Planning and Zoning Board

Staff Report

CASE NUMBER: Z17-007 (PLN2016-00951)
LOCATION/ADDRESS: The 2300 block of East McKellips Road (north side).
GENERAL VICINITY: Located east of Gilbert Road on the north side of McKellips Road.
REQUEST: Rezone from AG to RM-2 BIZ; and Site Plan Review.
PURPOSE: This request will allow for a multi-residential development.
COUNCIL DISTRICT: District 1
OWNER: Parry Investments, LLC.
APPLICANT: Porter Kyle, LLC.
STAFF PLANNER: Wahid Alam, AICP Planner II

The proposed Landscape Plan.

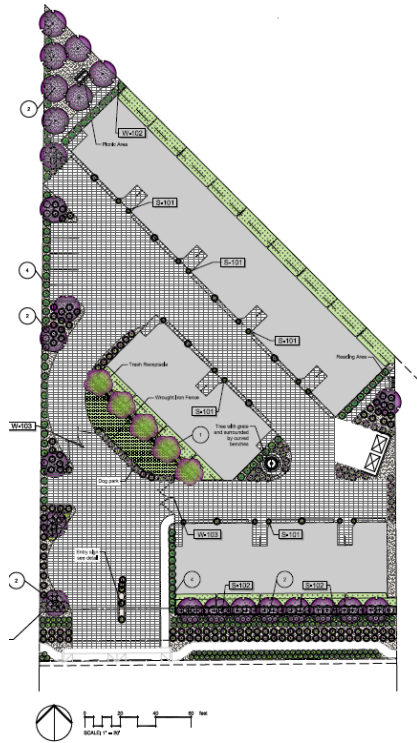
The proposed site plan layout provides public open spaces at two locations, which are primarily left over areas after placing the buildings. One area is located near the gates adjacent to the back yards of central building. The other area is located at the furthest northern corner in a triangular shape with approximately 50' in width. Both designated public open spaces are also identified in the preliminary grading and drainage plan as above ground retention basins, not designed for multi-purpose uses. The two public open spaces do not meet the open space location requirement.

With this proposal, the applicant is asking us to essentially consider all the driveway within the gated area, particularly the portion between the buildings, as part of their open space. The developer has been working on this concept and refining the drawings to have this develop as a people space that vehicles will also drive through. The most recent drawings show this with some difference in the pavement treatment next to the homes and with some potted plants in front of the units. This is moving in the right direction to accomplish this design concept but, from the information provided to date, staff believes the current proposal has still not gone far enough; more detailed drawings are needed to more fully evaluate what is being proposed. From what we see, it appears there needs to be greater differentiation between the areas of paving and the area next to the homes needs to be wider. The number of the pots may need to be increased and/or the size of the planting areas increased. There are things that could be done to the architecture of the buildings themselves to bring more interest at the ground plane and the garage doors could be more unique – maybe full glass doors to provide more of an open feel.

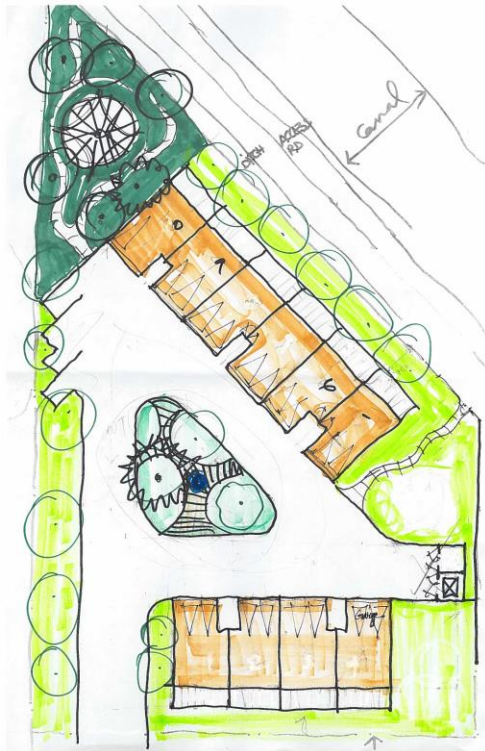
Staff is still hopeful that the additional design modifications can be developed so that the proposed design could be approved. If this cannot be done, it may be necessary to reduce the number of units on the property to provide an increase in open space amenity on the property. Staff has suggested at least two alternative site plans to improve the visual connections at the ground level.

Both alternative site plans use the same product the applicant is proposing, but each reduces the number of units to 10. The intent of Alternative 2 is to illustrate how with a single-car garage it opens up the ability to create private front yard/landscaped open space and provide a visual connection between the units through the addition of a front yard and the opportunity for additional windows along the internal street.
